STATE OF FLORIDA

DEPARTMENT OF ENVIRONMENTAL REGULATION

PERMIT/CERTIFICATION
 NO. AC 13-27742

Coal Handling/Conversion for
 Kilns 1,2 & 3

Figure 5-2
SO₂ EMISSIONS VERSUS KILN O₂,
KILN 3 BURNING COAL

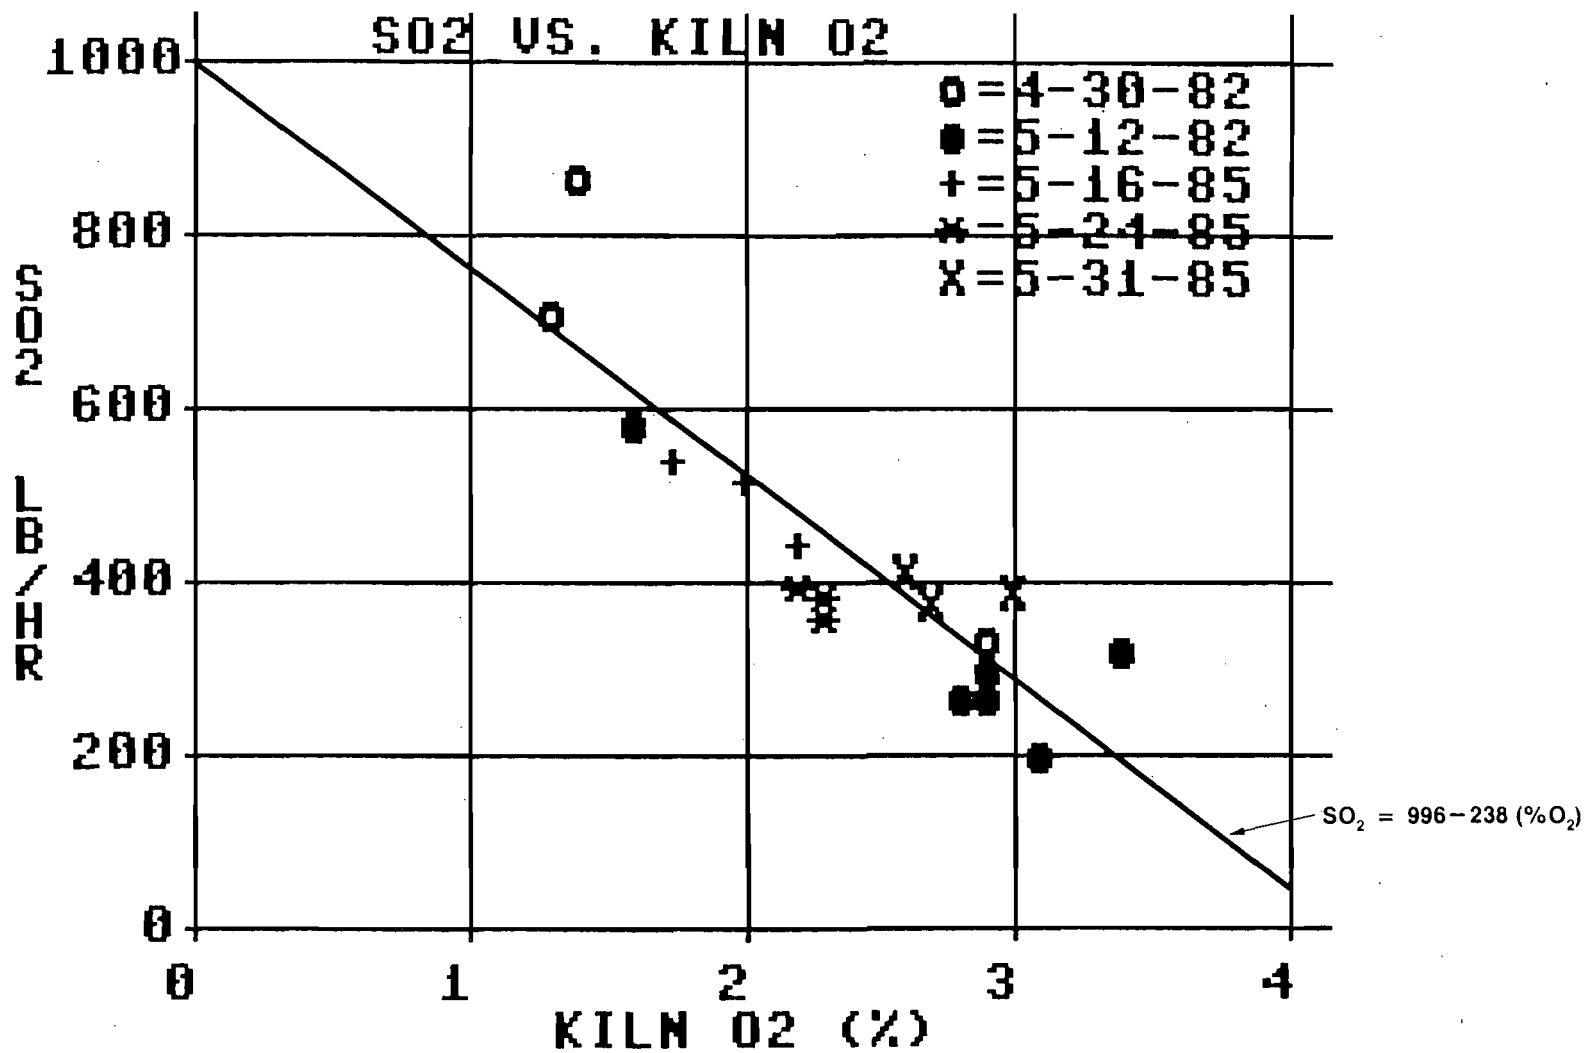
Presented in Figure 5-2 is the relationship between SO₂ emissions and kiln O₂ content. This figure shows a very strong correlation between SO₂ and kiln O₂ (an expected result, as discussed in Sections 3.0 and 6.0) and suggests a linear relationship. To test this relationship, a linear regression analysis was performed on the data. The following equation was found to describe the line of best fit:

This line is shown in Figure 5-2. The correlation coefficient (R) for this line of best fit is -0.88, indicating a fairly good correlation.

Figure I

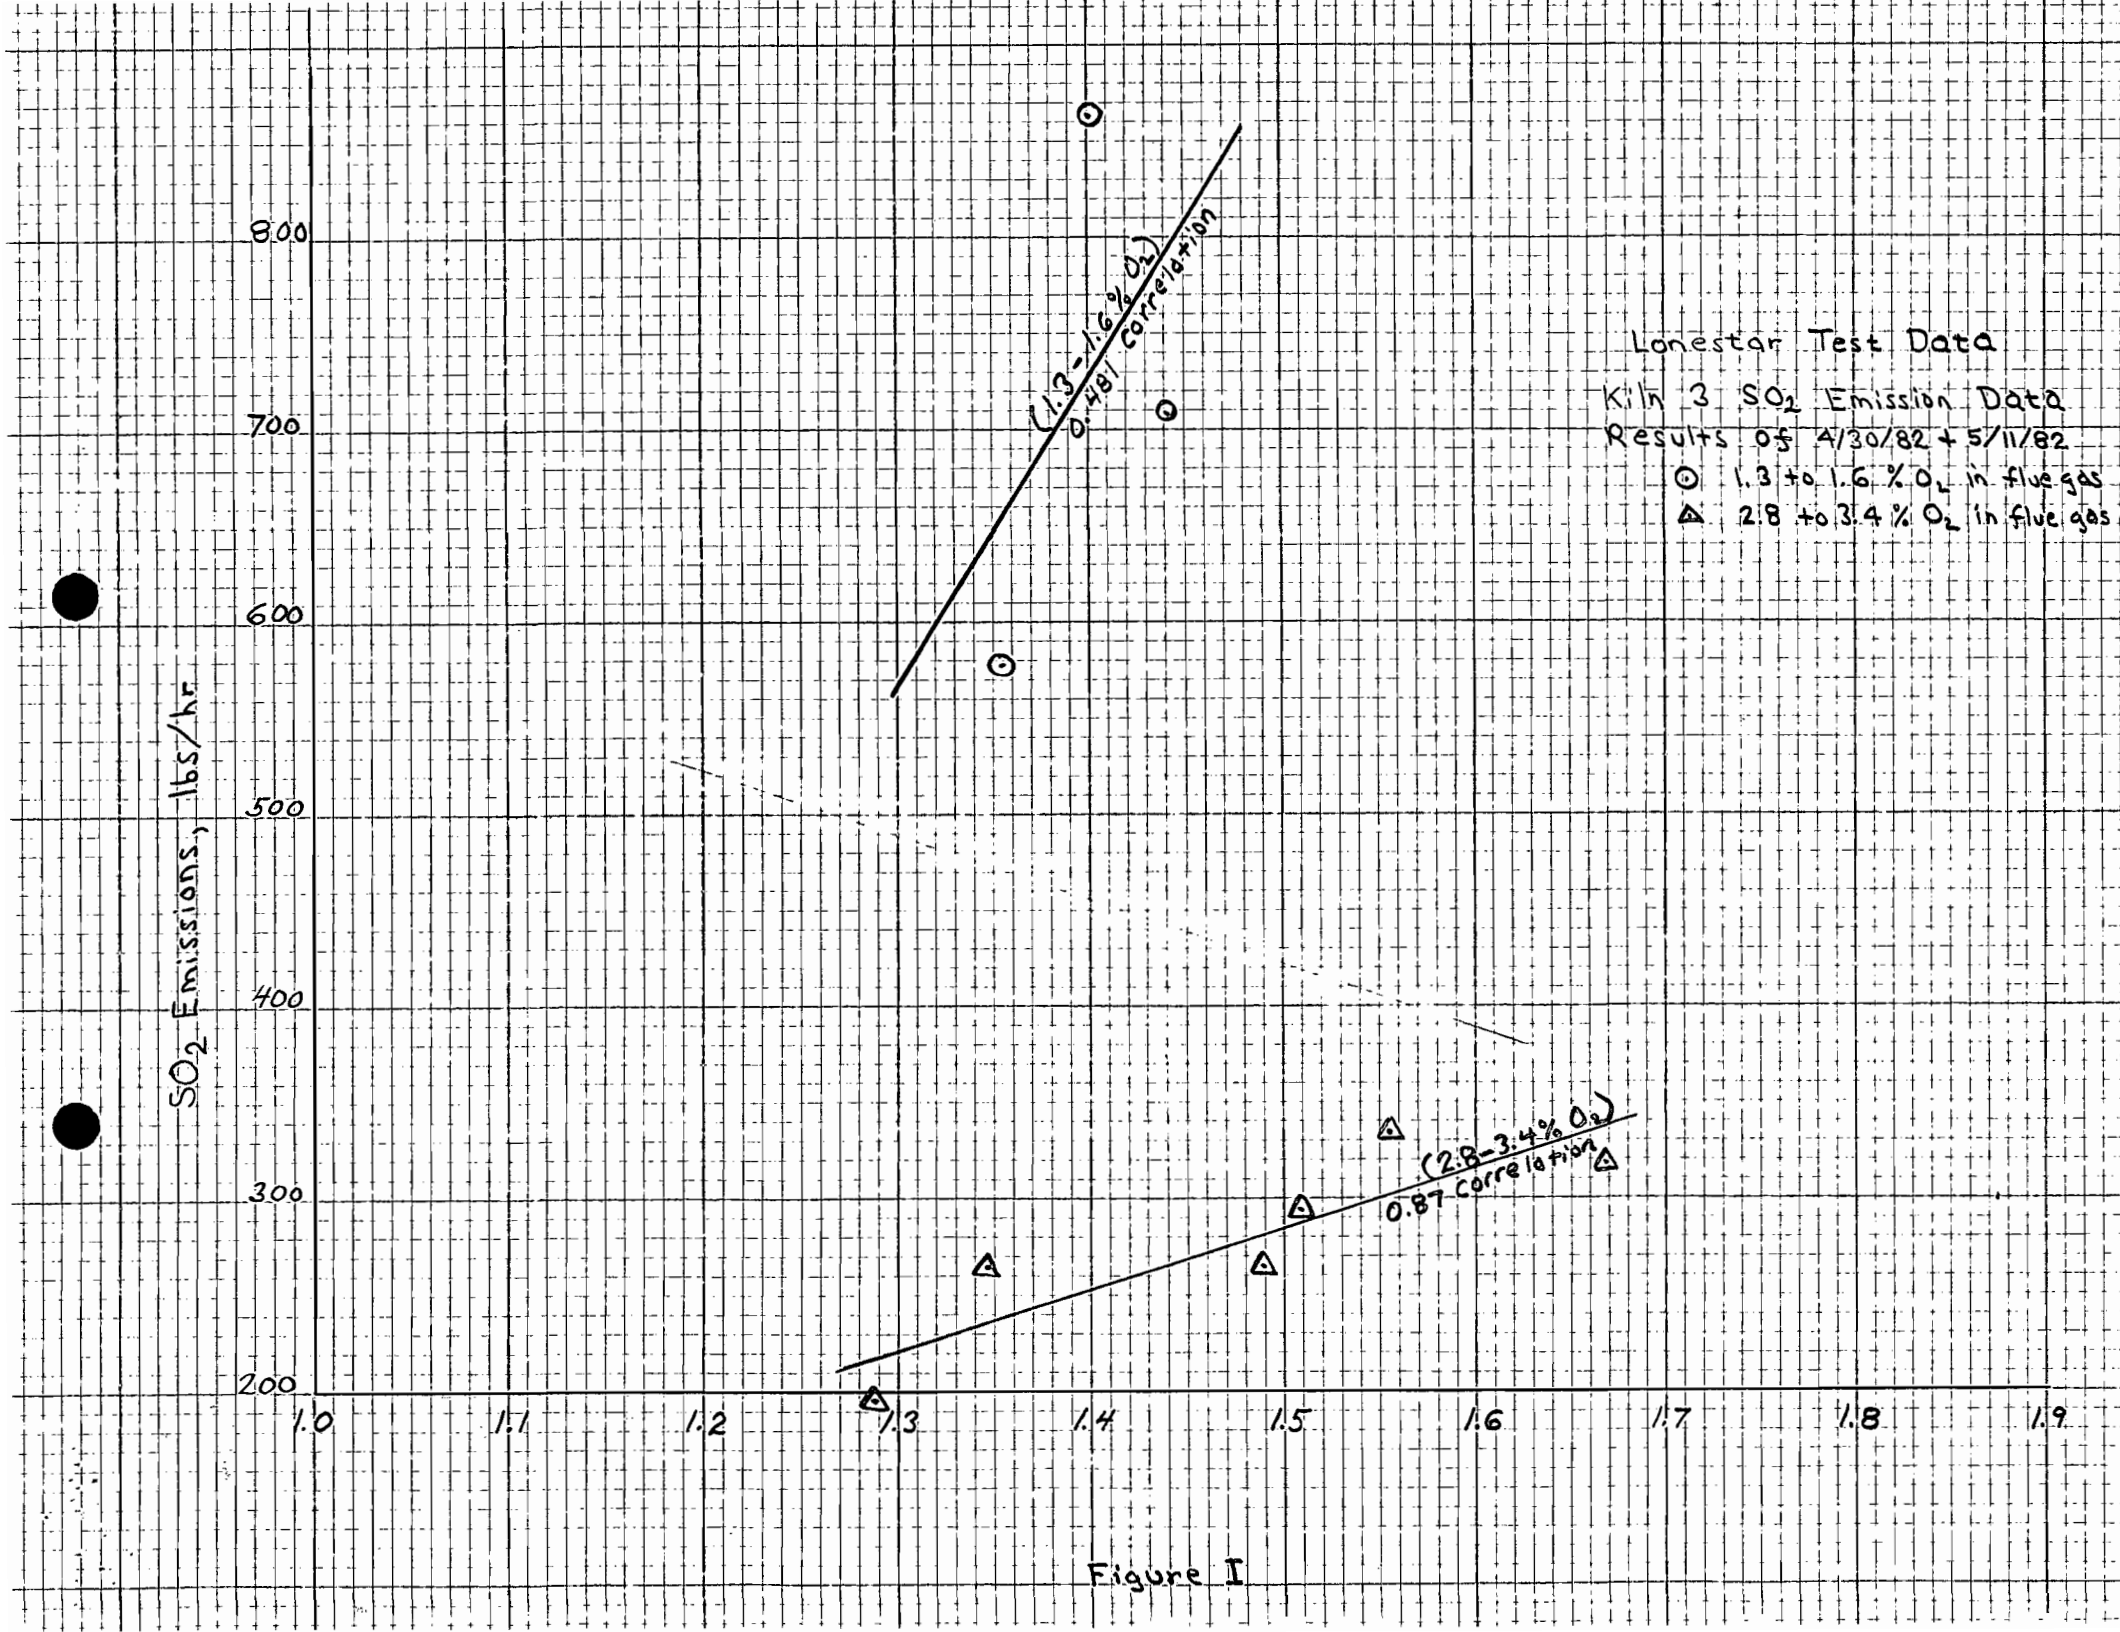
Calculations using the maximum feed and coal inputs to the kiln listed in the original application for permit to construct, the maximum sulfur content in the feed from Lonestar's June 13, 1983 letter, and a sulfur removal of 75 percent by the system shows the kilns would have to burn coal with no more than 0.75 percent sulfur for kilns 1 and 2 and 1.0 percent for kiln 3 to meet the sulfur dioxide emission standards now being requested. (See Table I and Figure 1) This is low sulfur fuel. As these emissions cause no
